NP-11-0044
September 30, 2011

Subject: Exelon Nuclear Texas Holdings, LLC
Victoria County Station
Early Site Permit Application
Update on Anticipated Environmental Report Revisions
Docket No. 52-042

Attachments: (1) Markup Pages of Victoria County Station ESPA ER Subsections
5.2.2.1 and 5.2.4
(2) Markup Pages of Victoria County Station ESPA ER Subsections
5.11.3.2 and 5.11.8
(3) Summary of Regulatory Commitments

Figure 5.11-2 Comparison of the 1947-1989 Monthly Historical Freshwater Inflow Frequency Distribution to Similar Monthly Distributions for the Five Modeled Hydrological Scenarios used in the Bio-statistical Evaluation

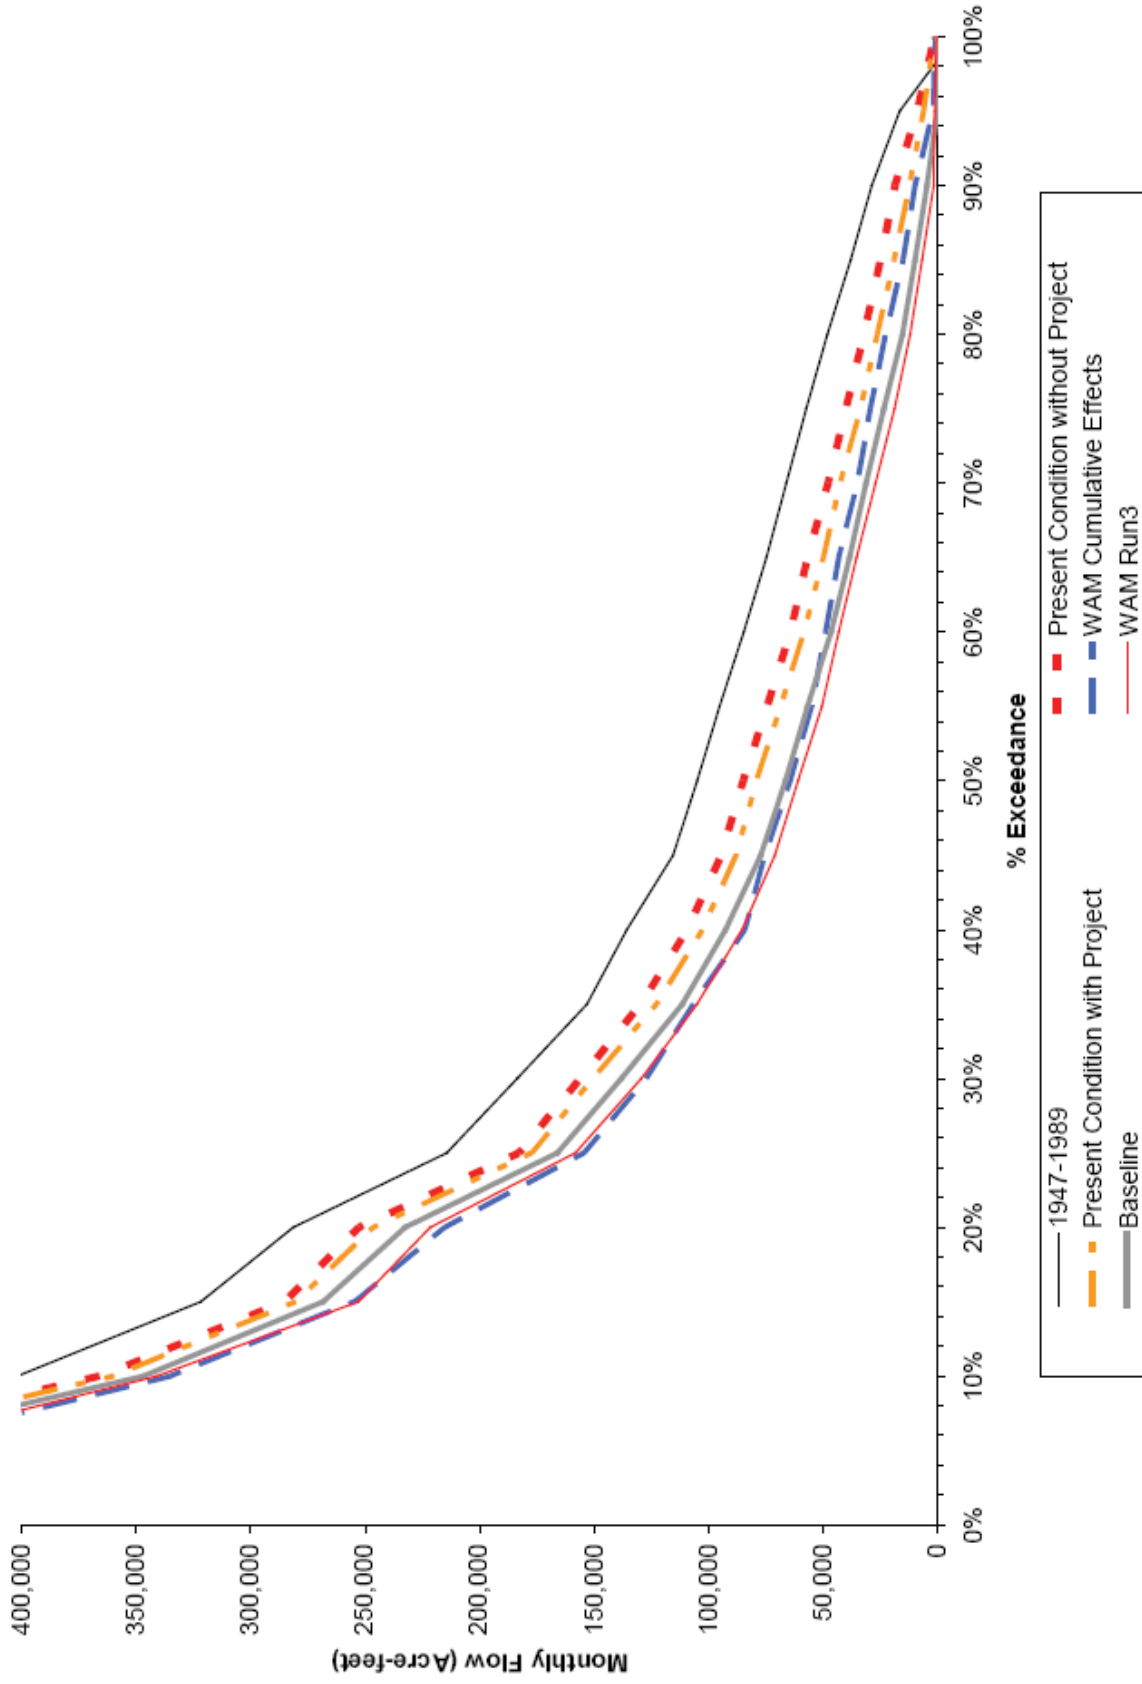
Figure 5.11-2 provides a comparison of the historical frequency distribution of monthly freshwater inflows to San Antonio Bay with similar distributions generated using the five modeled hydrological scenarios (Present Conditions without and with VCS, Region L Baseline, Region L Cumulative Effects, and TCEQ WAM Run 3) used in the bio-statistical evaluation. The relatively tight pairing of the lines depicting the Present Conditions without VCS and Present Conditions with VCS scenarios demonstrates the relatively small impact that operation of VCS would have on monthly inflows to the bay (see Subsection 5.2.2.1) compared to the modeled present demand. The comparatively larger gap between the lines representing the Present Conditions without VCS scenario and the three full utilization scenarios indicates that the bulk of reductions of inflows to the San Antonio Bay system results from full utilization of existing water rights. This observation is consistent with the findings of the cumulative effects analysis conducted in the Region L 2011 Regional Water Plan, as summarized earlier in Subsection 5.11.3.2.
